35/13-00M 4 Magnolia Parkway  
(Chevy Chase Village HD)

SUBJECT: Historic Area Work Permit Application - HPC Decision 35/13-00M

**EXPEDITED**  
**HISTORIC PRESERVATION COMMISSION STAFF REPORT**

<b>Address:</b>	4 Magnolia Parkway, Chevy Chase	<b>Meeting Date:</b>	05/24/00
<b>Applicant:</b>	Stephen and Helene Sacks	<b>Report Date:</b>	05/17/00
<b>Resource:</b>	Contributing Resource Chevy Chase Village Historic District	<b>Public Notice:</b>	05/10/00
<b>Review:</b>	HAWP	<b>Tax Credit:</b>	No
<b>Case Number:</b>	35/13-2000M	<b>Staff:</b>	Michele Naru
<b>PROPOSAL:</b>	Window Replacement	<b>RECOMMEND:</b>	Approve w/cond.

Window #1 - Kitchen

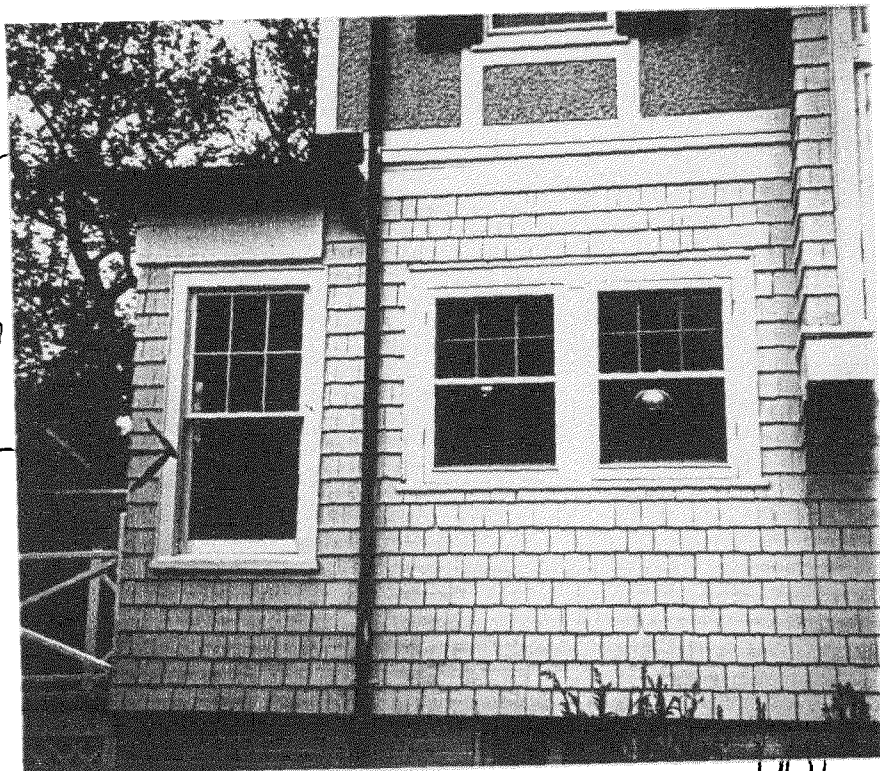
Replace

1 over 1 - double hung

30 1/2" wide x 33" high

on side of house between #  
4 Magnolia and #3 Hesketh

with

New window to match

existing window found on  
Hesketh street side of house

6 over 1 - double hung

31" wide x 64" high
